Access Compliance Report

Public Rights-of-Way

| Intersection ID: 11796 | Main Street: N_PINE_ST | Cross Street: W_6TH_ST | Location: S |
| ADA ID: AC7839D34A51 | Ramp Type: Perp | Initial Pass/Fail: Fail | Overall Compliance: No |

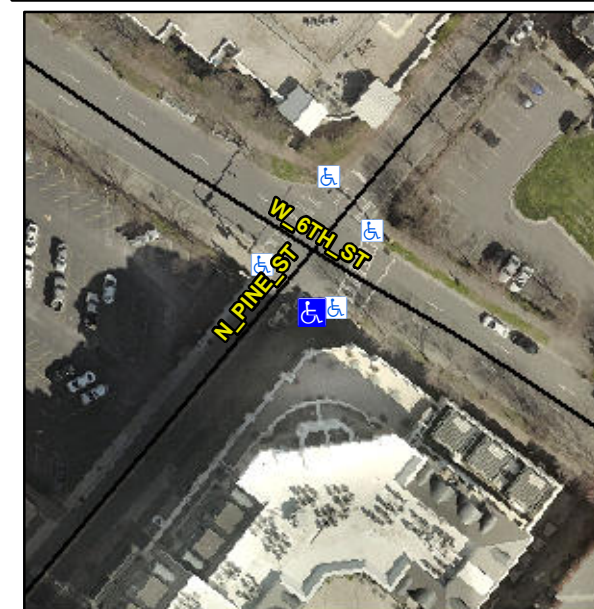
Not Found, R304.2.2, R304.5.3

| Compliance | Description | Data | Compliance | Description | Data |
|------------|-----------------------|-------|------------|-----------------------------|------|
| N/A | Ramp Length (in) | 47.0 | No | Ramp Slope (%) | 8.8 |
| Yes | Ramp Width (in) | 59.0 | No | Ramp XSlope (%) | 2.6 |

Remove & Replace Entire Ramp.
